M5 Motorway Westbound Traffic Upgrade team
Transport for NSW
PO Box 973
PARRAMATTA NSW 2124

29th September 2022

Re: M5 Motorway Westbound Traffic Upgrade

Figure 5: Cross section of the new bridge over the Georges River showing the 3.5m shared path and the 2.5m shoulder (Source: TfNSW, 2022 REF)

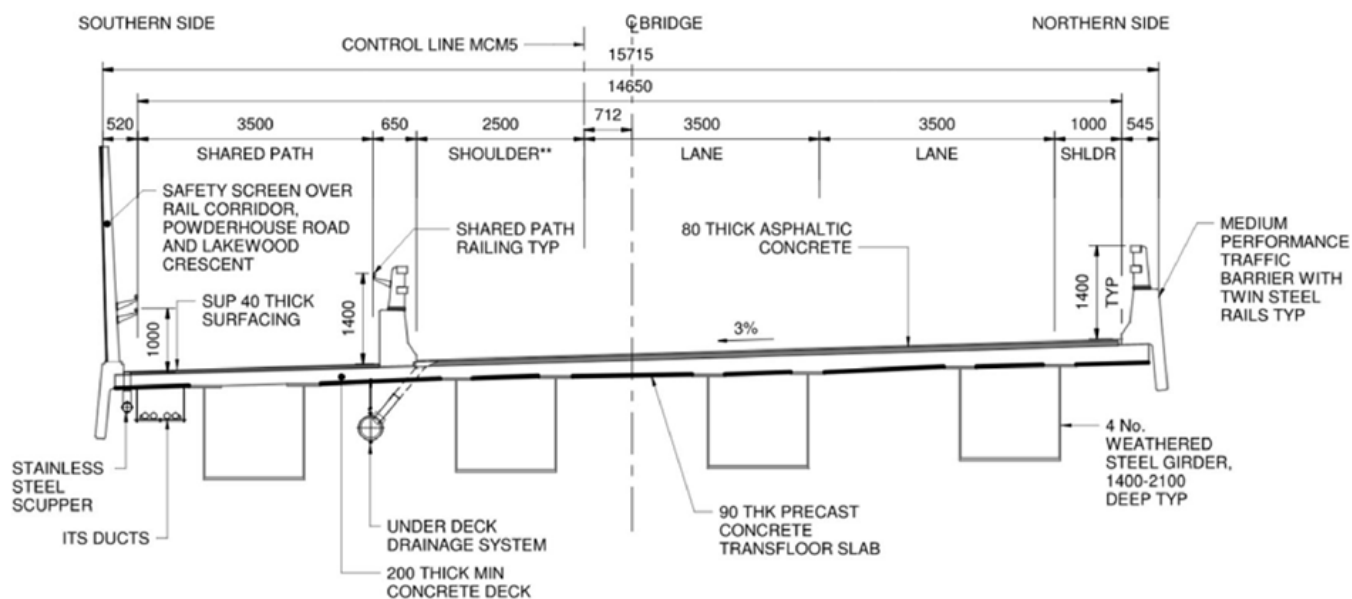
The REF specifies that the **shared path will be 3.5m wide**. This complies with the minimum widths specified by Austroads (Figure 4)^{xiii}. A generous path accommodates a range of mobility options such as cargo bikes and disability scooters and ensures faster cyclists can overtake without compromising pedestrian comfort.

2.5m wide shoulders are specified throughout the new sections of the motorway so cyclists can still use the main line if desired. A 2.5m shoulder will be included in the new underpass.

Figure 6: The proposed Moorebank Avenue intersection (Source: TfNSW, 2022 REF)

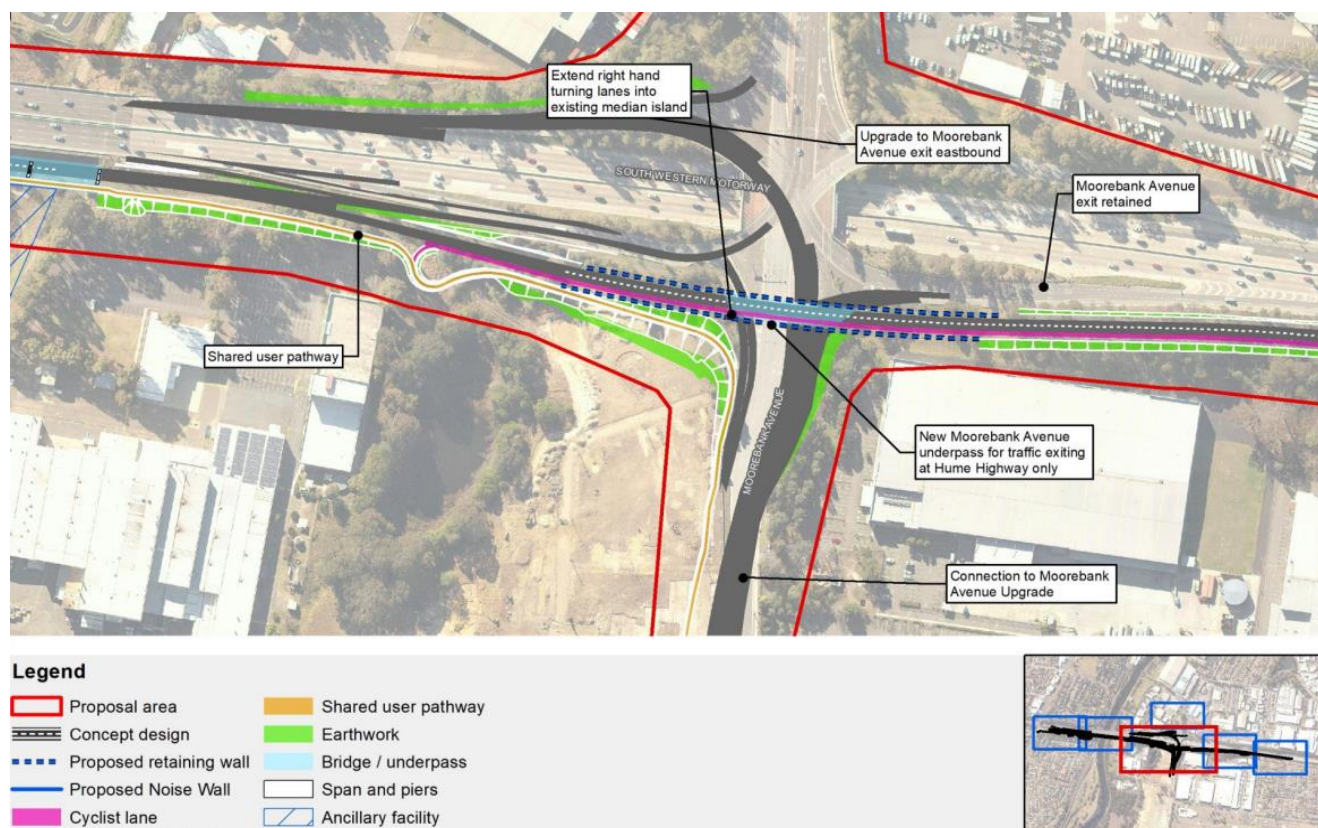
Heading west, cyclists will be directed to use the underpass shoulder. On the western side of the underpass there is a choice to exit the shoulder onto the shared user path to cross the river or access Moorebank Avenue, or to continue travelling west on the M5 Motorway by crossing a single lane of traffic to re-join the mainline via the existing entry ramp (Figure 6)

- Another concern is the **movement of construction trucks** and site vehicles across pedestrian and cycling paths in the area to access the contractor's compounds. Without the detailed Traffic Management Plan (TMP) it is difficult to assess the impact of construction on active transport.
- It is not clear how cyclists would rejoin the motorway mainline shoulder from the western end of the new shared path. Although confident cyclists travelling west can remain on the M5, those approaching from the

riverside shared path may also want to access the shoulder to head towards Campbelltown. This is currently possible by crossing the slip lane (Figure 9).

- If access to the motorway from the new shared path is provided for bikes, what measures will be in place to ensure that pedestrians will be prevented from walking onto the M5?

Figure 7: The western end of the new shared path showing proposed connections to the Hume Highway and Lakewood Crescent (Source: TfNSW, 2022 REF)

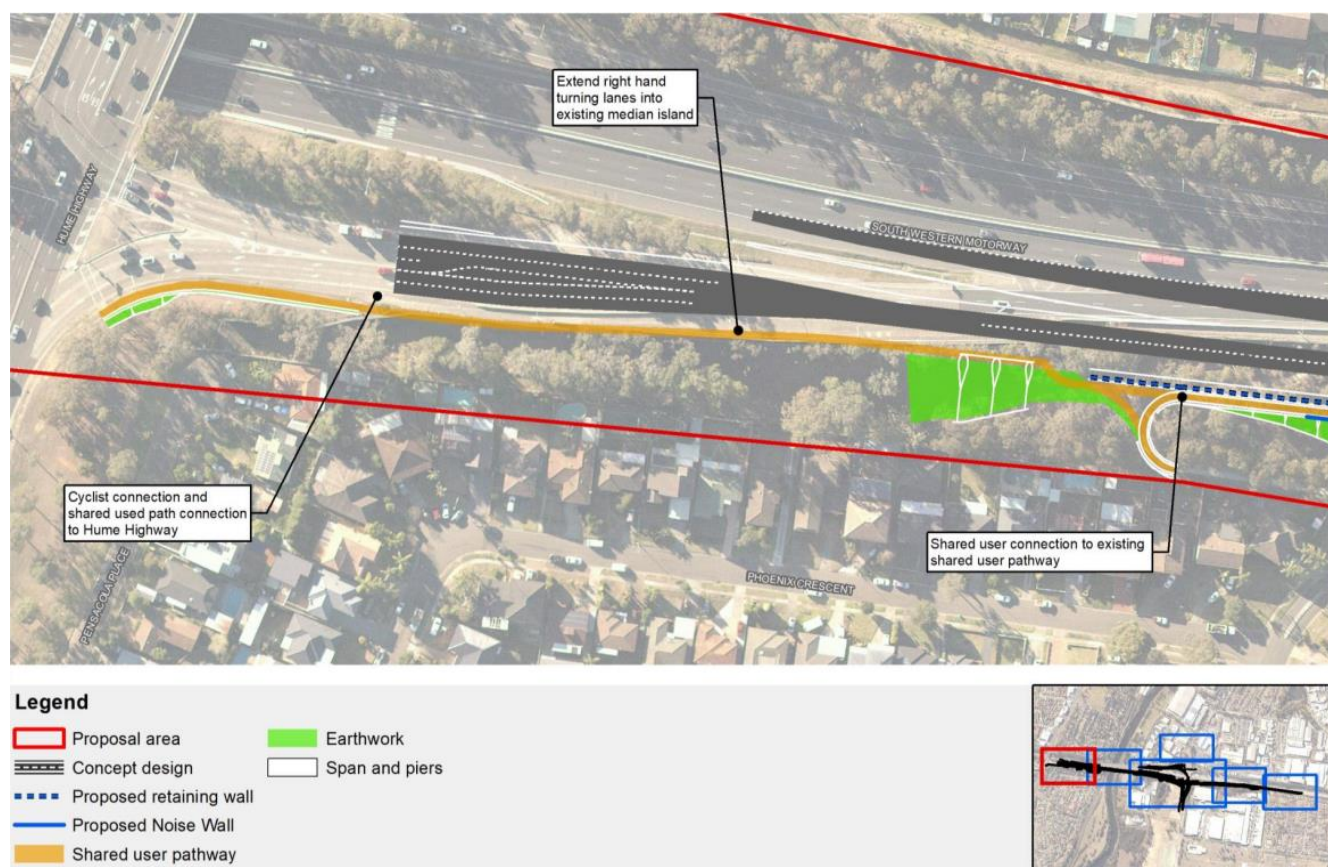
On the western side of the river (Figure 7), a connection to Lakewood Crescent in Casula will provide access to the well-established Liverpool to Parramatta Rail Trail which has recently been extended south to Glenfield Station, creating a high-quality and pleasant route beside the Georges River and Leacock Regional Reserve via the Casula Powerhouse Arts Centre.

The western end of the new shared path should seamlessly merge with the shared path along the Hume Highway.

Figure 10: The current connection to the rail trail regional cycleway is indirect, using Woodbrook Road to pass under the rail line. An elegant bridge could be delivered where shown with an orange line. (Source: Google Maps)

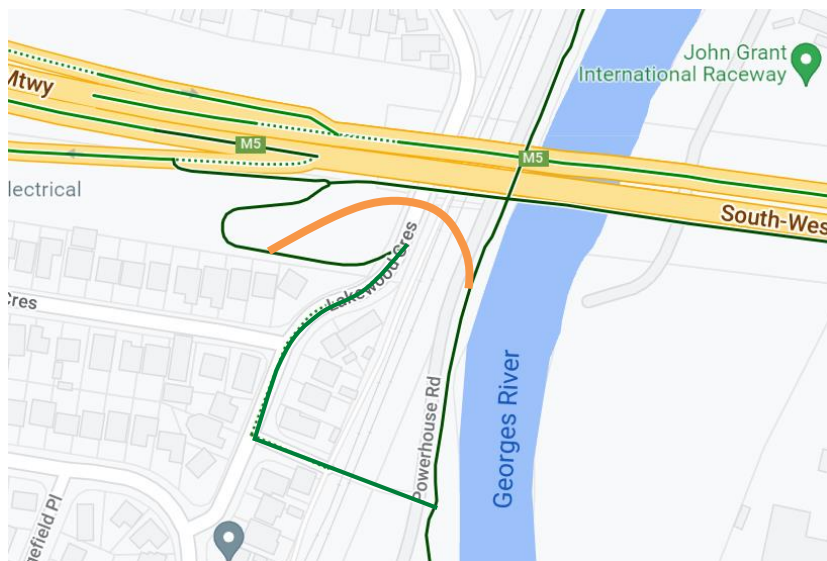
For example, the shared path spur to Lakewood Crescent should lead to a cycle and pedestrian bridge over the rail line to create much better access to the rail trail shared path and Powerhouse Road (Figure 10).

Figure 11: Locating the weir that needs a new pedestrian and cycle bridge. (Source: Google Maps)

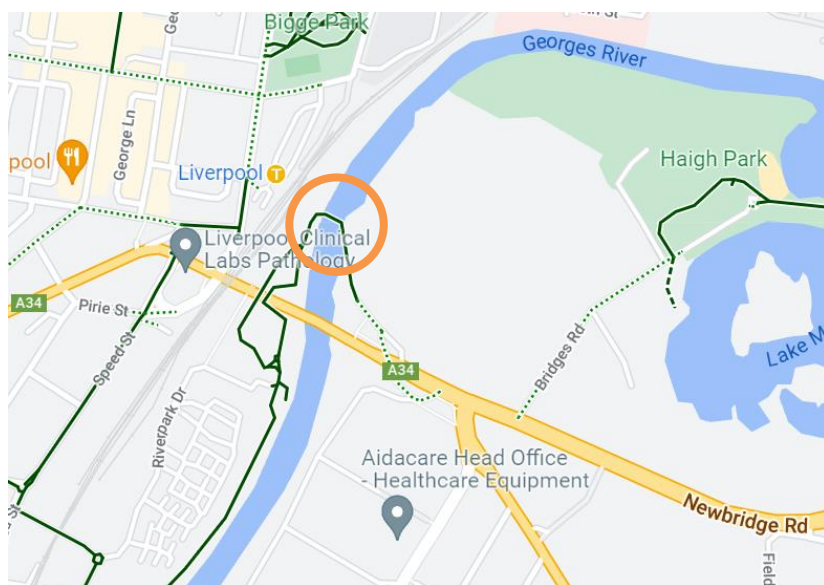
Another much needed project is a bridge across the weir at Liverpool. This shows up as a cycle route on Google Maps (Figure 11) but is often under water or too slippery with algae to cross safely. A shared use bridge at this point, linking Liverpool to Chipping Norton Lakes, would be immensely useful in meeting the transport needs of a rapidly growing population who might otherwise resign themselves to private car use.
